Planning and Zoning Commission - Special Meeting AGENDA

Tuesday, March 23, 2021 at 4:30 PM
Ketchum City Hall
480 East Avenue North, Ketchum, ID 83340

3. ACTION ITEM: Amendment to P18-131 - Swan Streambank Alteration: 401 Northwood Way (Lot 12, Chateau of Northwood), owned by Bob and Sandra Swan, and adjacent riverbed (Ketchum FR NWSE TL 7801 SEC 12 4N 17E River Bed) owned by the City of Ketchum. The Commission will consider a proposed amendment to Floodplain Development / Stream Alteration permit P18-131, the Swan Stream Alteration/Bank Stabilization Floodplain Development and Waterways Design Review Permit. *Continued from March 9, 2021*

4. ACTION ITEM: 128 Saddle Road Design Review and Preliminary Plat with Phasing Agreement: 128 Saddle Road (Lot 2, Kneeland Subdivision) The Commission will consider and take action on applications for a new development of four (4) detached townhome units to be accessed from a private driveway taking access from Valleywood Drive. The proposed Floor Area Ratio, cumulatively, for the proposed development is 0.31.

- C. Plans, “Swan, Sandra River Restoration Project,” Three (3) sheets: Site Plan, Sections and Details, and Channel Cross-Sections, dated September 28, 2020

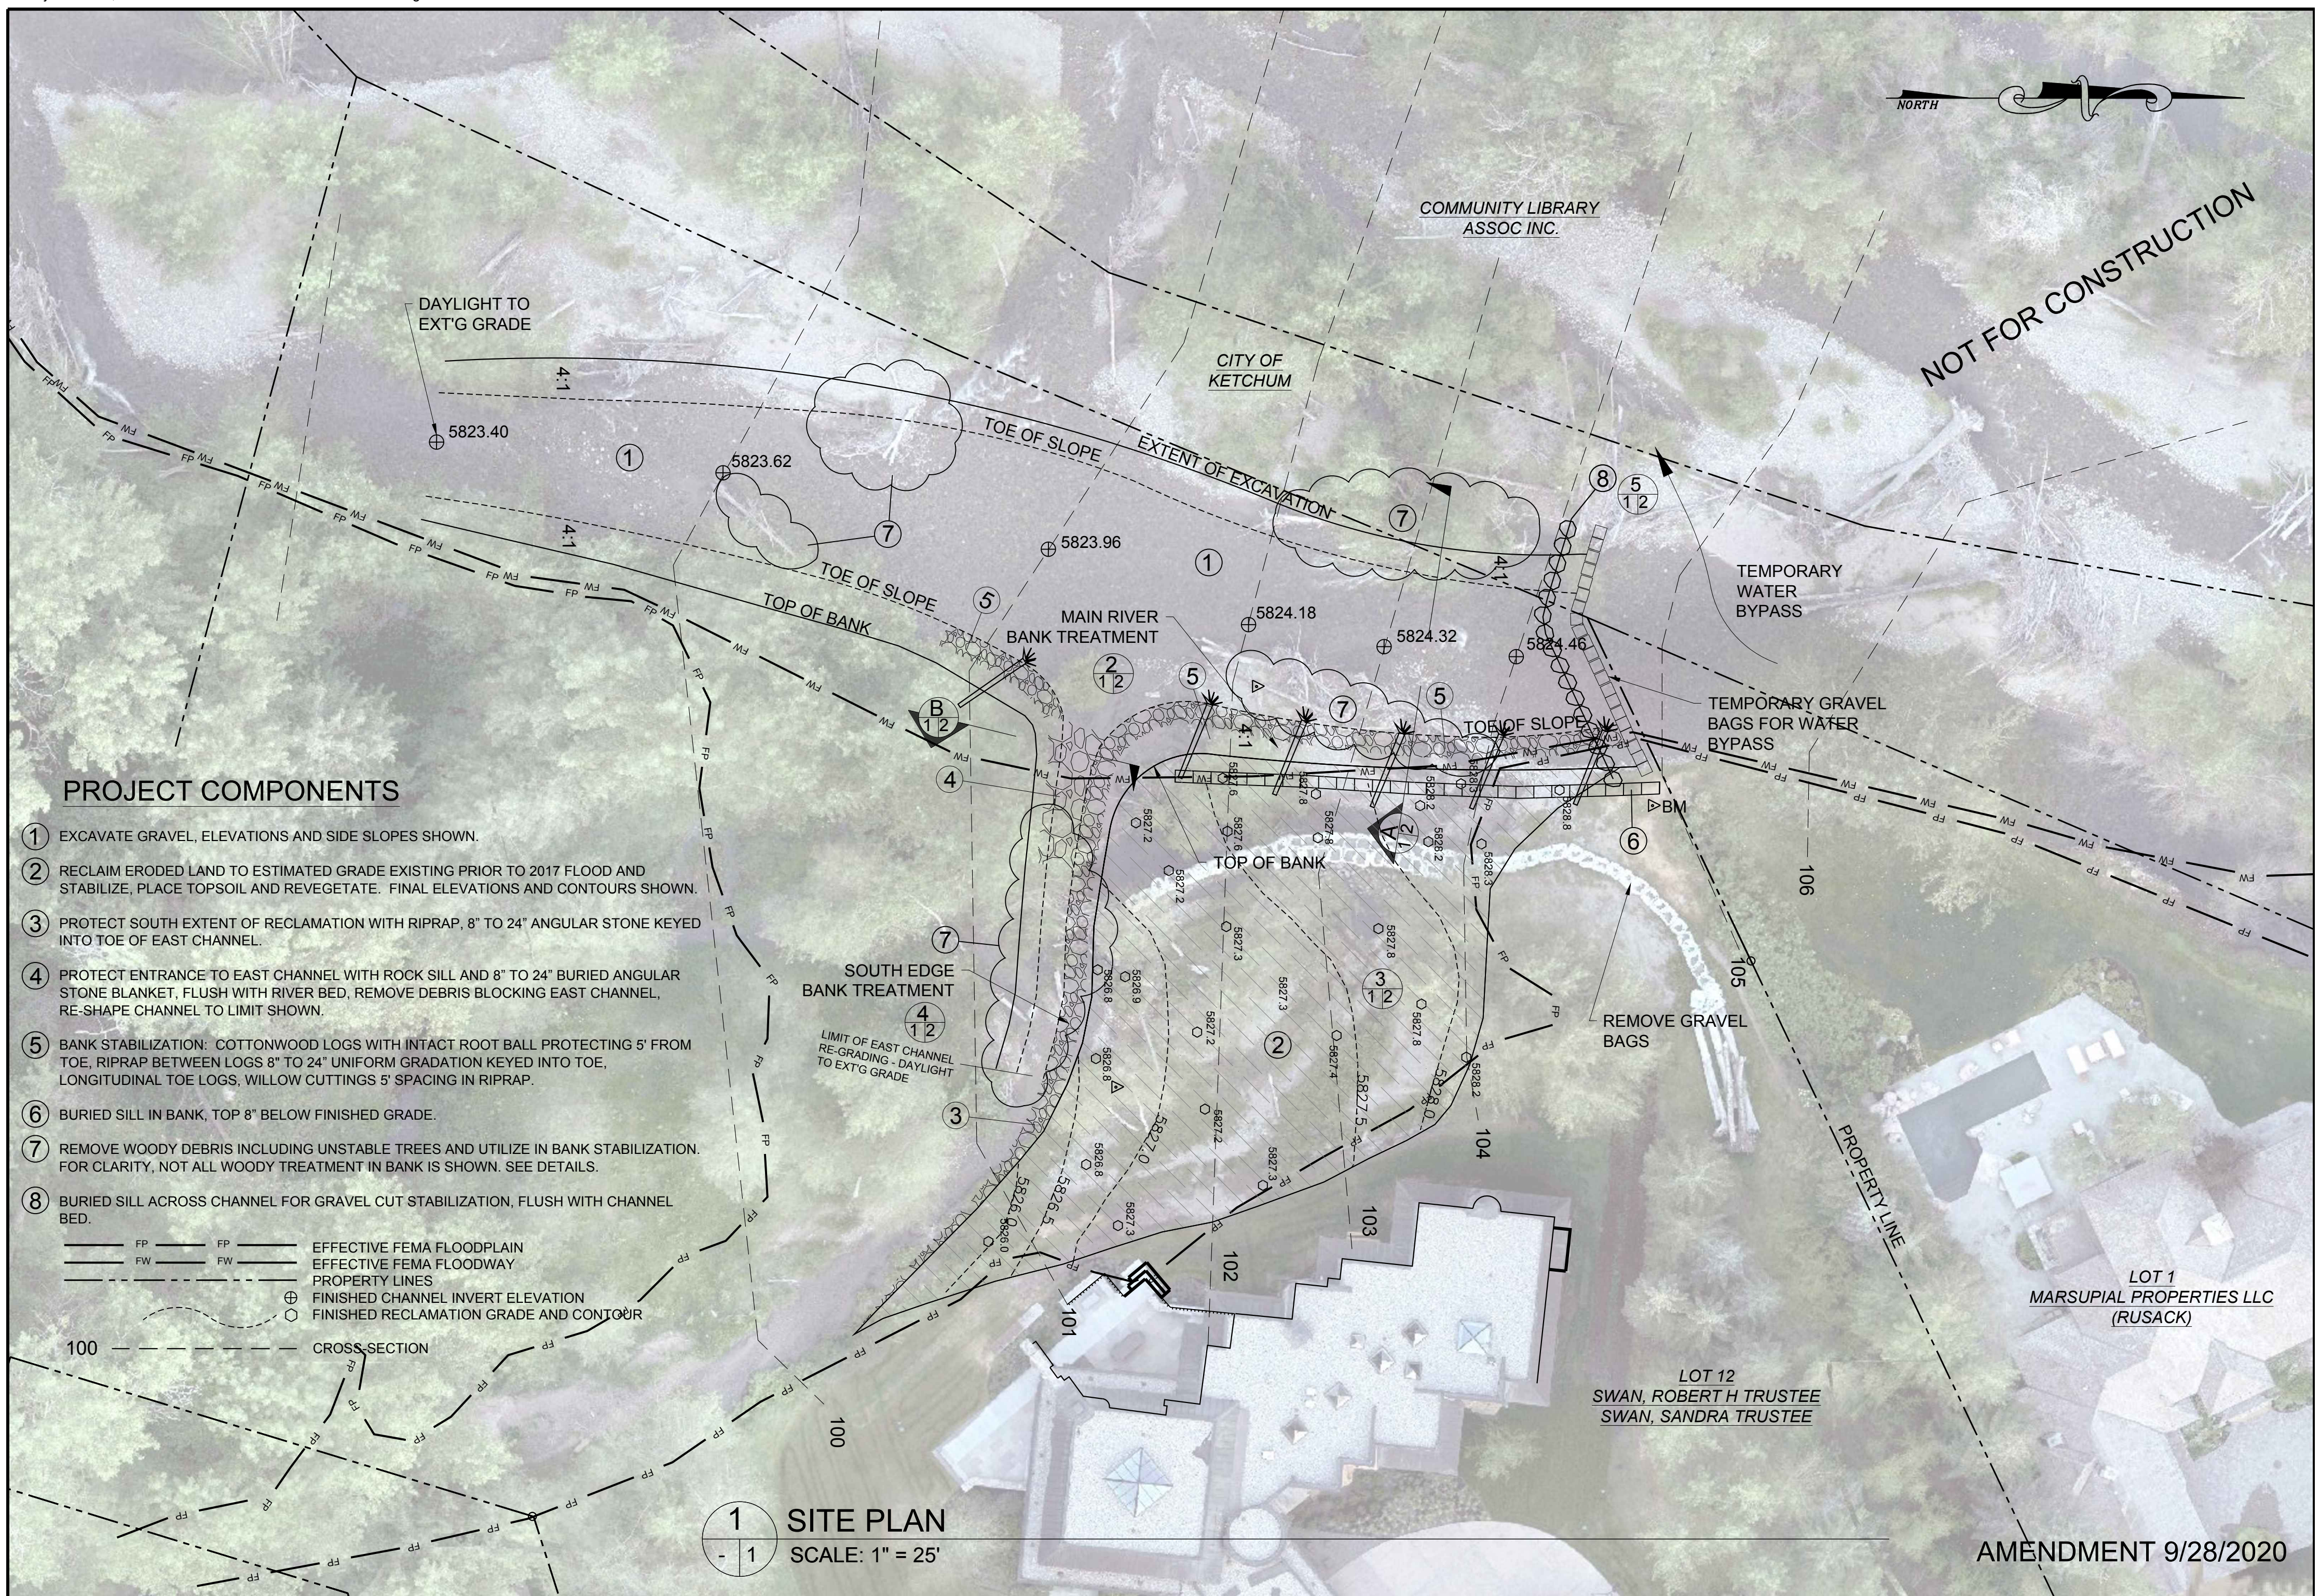
As described in Paragraph A of the Amended Narrative, the Amended Drawings remove all work of any kind on Lot 1, referring to 411 Northwood Way, which is owned by Marsupial. Prior to the proposed amendment, the Swan River Restoration Project (the “Swan Project”) proposed to complete both river channel grading and bank stabilization work extending upstream approximately 60 feet onto the Marsupial property. As one component of the Swan Project is to lower the river channel elevation adjacent to the Swan property as shown in Sections 100 through 104 on Sheet 3 of the Amended Drawings, the work previously proposed as taking place on the Marsupial property was reasonable and necessary to provide a transition section between the Swan Project and existing upstream channel elevations. Also, as lowering the river channel elevation adjacent to the Swan property led to a predicted increase in river flow velocity, the Swan Project included a provision to stabilize the river bank adjacent to the Marsupial property through the aforementioned transition section.

As depicted on the amended Drawings, the river channel excavation and grading work is now proposed to terminate just downstream of the shared Swan/Marsupial property line. This abrupt project transition will effectively create a vertical discontinuity in the river channel bottom between 18 and 30 inches in height over a horizontal length of approximately 15 to 25 feet as demonstrated by Sections 104 and 105 on Sheet 3 of the Amended Drawings. This resultant over-steepened section of river channel will be highly unstable and is expected to rapidly headcut upstream onto the Marsupial property. As the Amended Swan Project is no longer proposing to stabilize the approximately 60 feet of river bank through the transition section along the Marsupial property, the anticipated effect will be to further exacerbate the bank erosion issue already being experienced by Marsupial in this area as shown in Figure 1. The Amended Drawings do include a rock sill (Note 8, Sheet 3) that will serve to limit the height of the headcut to the previously mentioned 18 to 30 inches, but will not limit upstream headcut migration.

A standalone Swan Project requires a dewatering plan that backs water up onto the Marsupial property and will result in a more uncontrolled water diversion across an alluvial island into the adjacent main river channel, and may require temporary excavation as referenced in the Amended Narrative.

Based on our review, we request a denial of the Amended Swan Project until the concerns presented above have been addressed to the satisfaction of Marsupial, or both the Swan and Marsupial Projects have been coordinated to function as a single cohesive project that provides for long term channel stability and appropriate protections to the affected landowners.

Sheet No:
L3.0

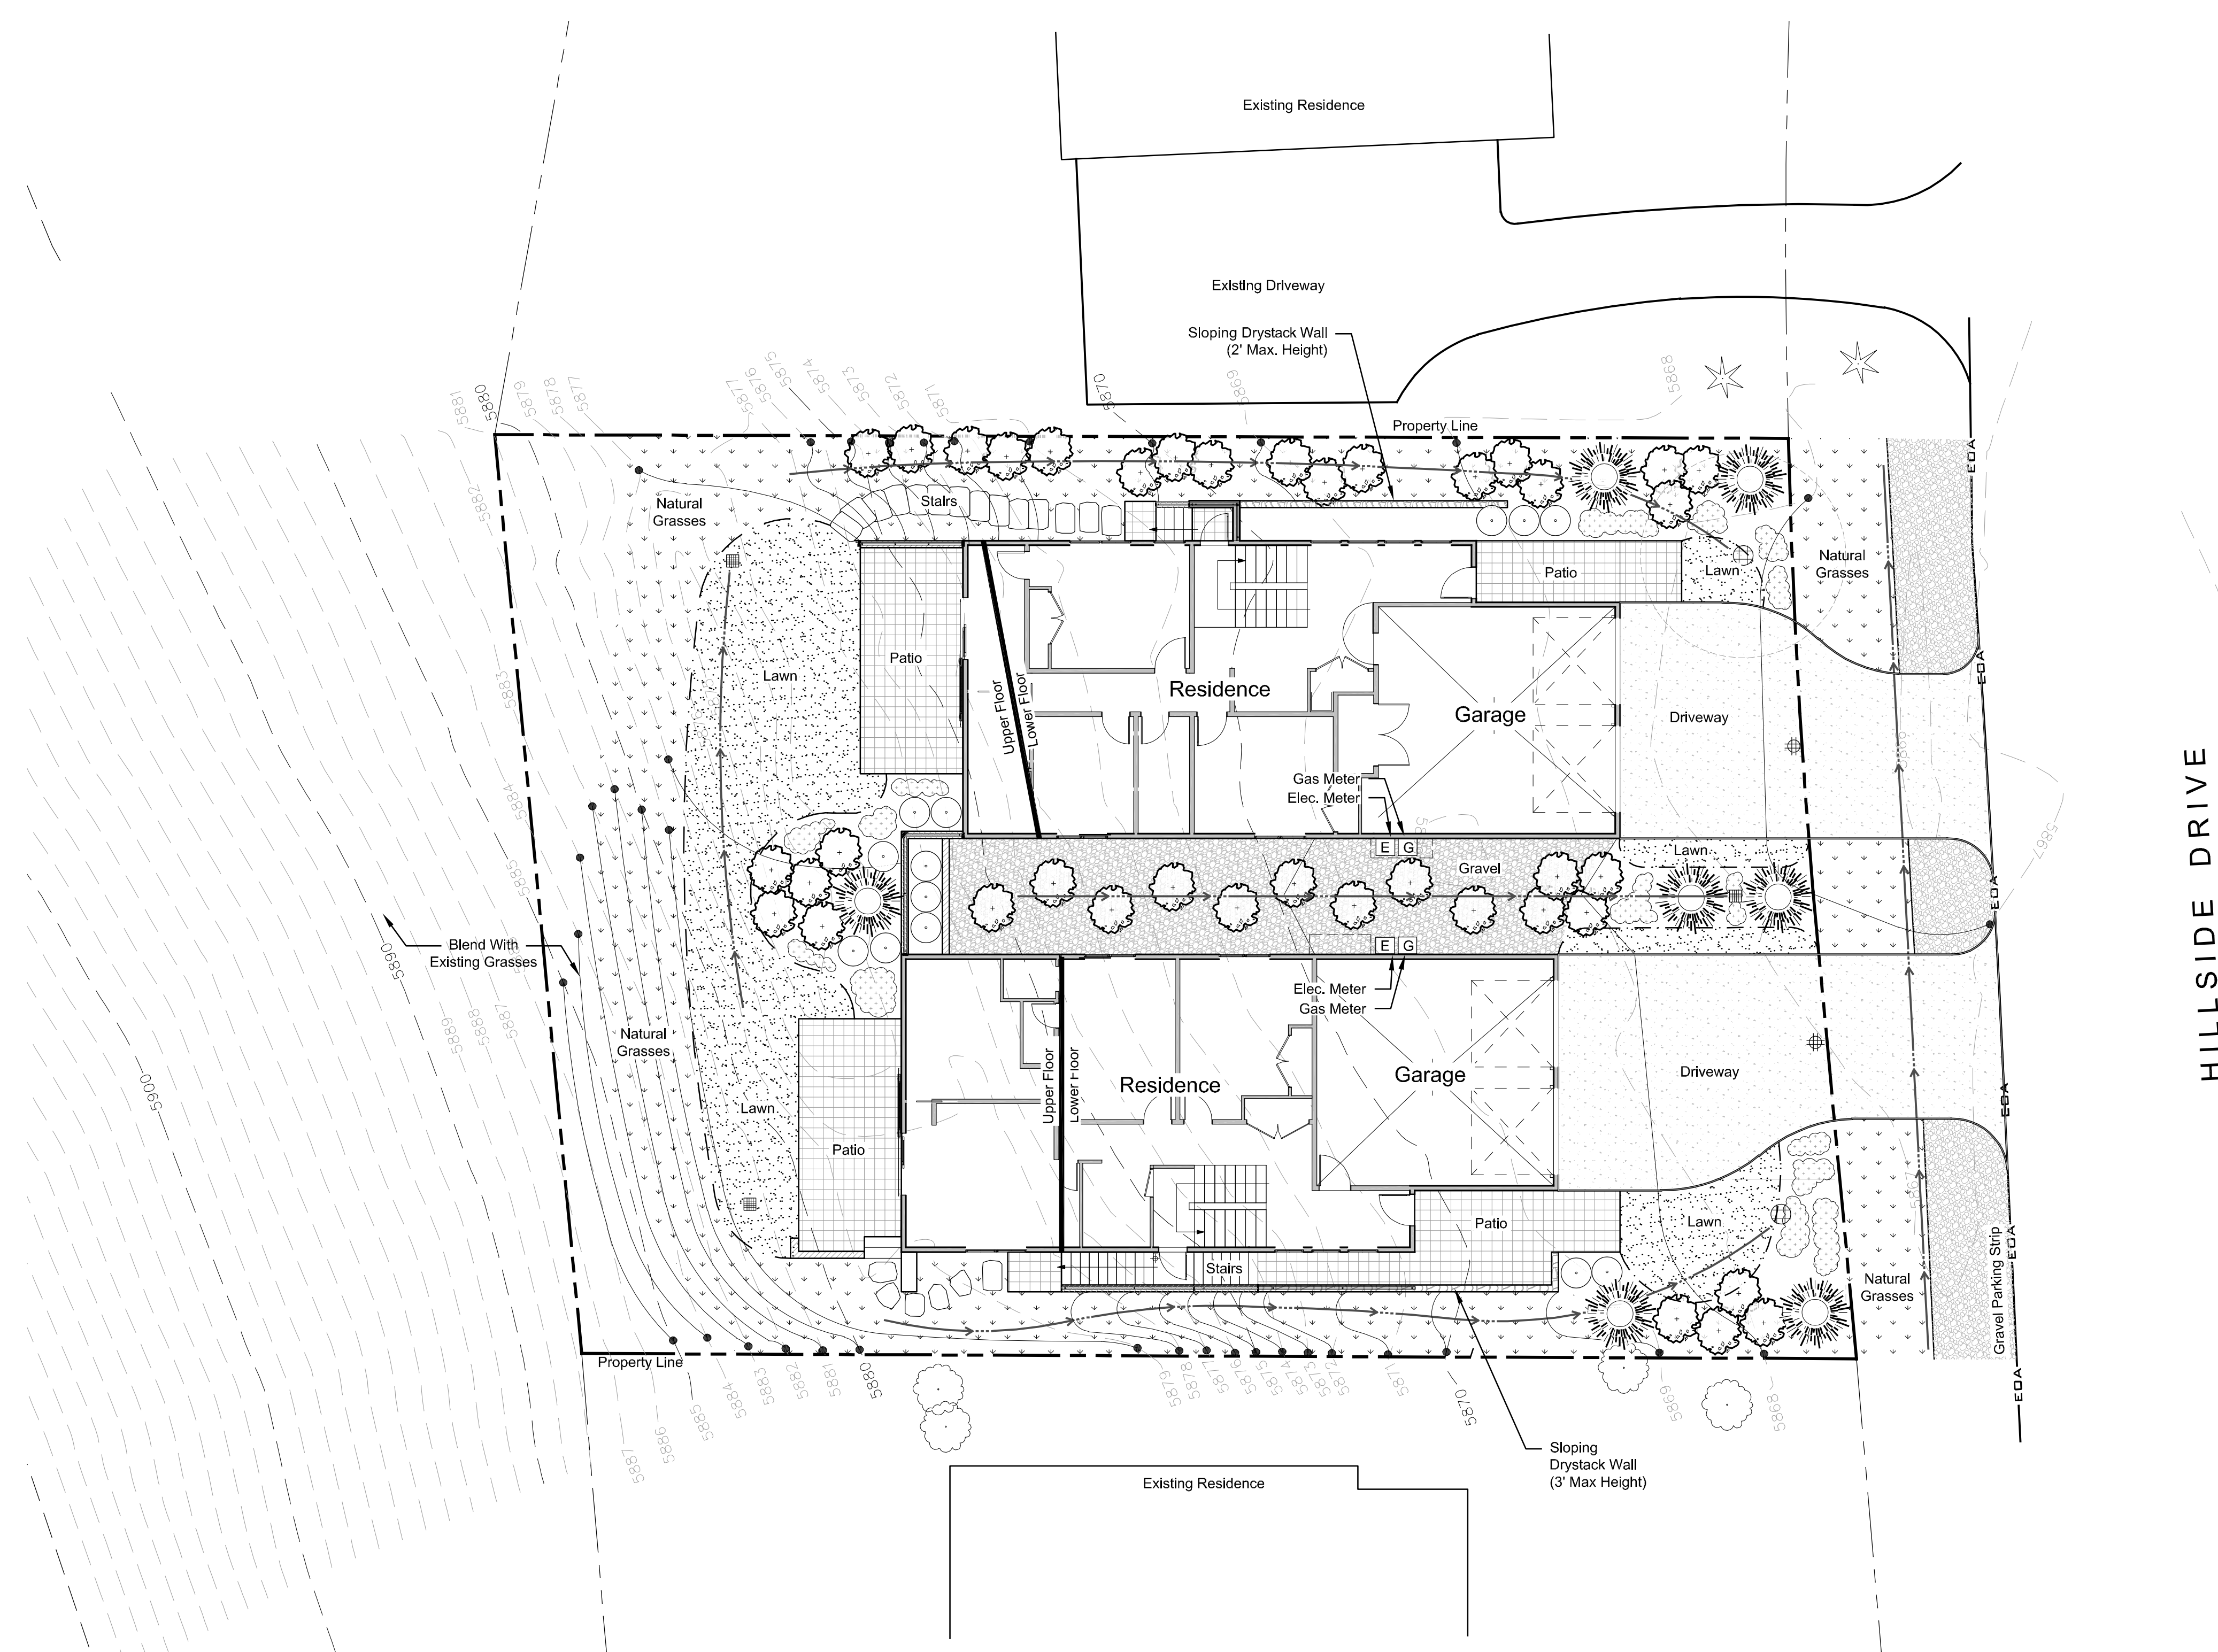
<i>Staff Comments</i>	<i>See sheet L3.0.</i>
	<input type="checkbox"/>	<input type="checkbox"/>	17.96.060(I)(2)	Landscape materials and vegetation types specified shall be readily adaptable to a site's microclimate, soil conditions, orientation and aspect, and shall serve to enhance and complement the neighborhood and townscape.
			<i>Staff Comments</i>	<i>The applicant proposes to use a natural grass mix for the majority of the property and a limited amount of lawn (1,000 square feet). The proposed evergreen trees (Colorado Spruce) and deciduous trees (Quaking Aspen) are common in the vicinity and throughout Ketchum.</i>
	<input type="checkbox"/>	<input type="checkbox"/>	17.96.060(I)(3)	All trees, shrubs, grasses and perennials shall be drought tolerant. Native species are recommended but not required.
			<i>Staff Comments</i>	<i>The applicant proposes to use a natural grass mix for the majority of the property and a limited amount of lawn (1,000 square feet). The proposed evergreen trees (Colorado Spruce) and deciduous trees (Quaking Aspen) are drought tolerant once established, with Colorado Spruce being among the most drought-tolerant species of spruces.</i>

<i>Staff Comments</i>	<i>N/A.</i>
<input checked="" type="checkbox"/>	<input type="checkbox"/>	<input type="checkbox"/>	17.96.060(I)(1)	Landscaping is required for all projects.
			<i>Staff Comments</i>	<i>See sheet L3.0.</i>
<input checked="" type="checkbox"/>	<input type="checkbox"/>	<input type="checkbox"/>	17.96.060(I)(2)	Landscape materials and vegetation types specified shall be readily adaptable to a site's microclimate, soil conditions, orientation and aspect, and shall serve to enhance and complement the neighborhood and townscape.
			<i>Staff Comments</i>	<i>The applicant proposes to use a natural grass mix for the majority of the property and a limited amount of lawn (1,000 square feet). The proposed evergreen trees (Colorado Spruce) and deciduous trees (Quaking Aspen) are common in the vicinity and throughout Ketchum.</i>
<input checked="" type="checkbox"/>	<input type="checkbox"/>	<input type="checkbox"/>	17.96.060(I)(3)	All trees, shrubs, grasses and perennials shall be drought tolerant. Native species are recommended but not required.
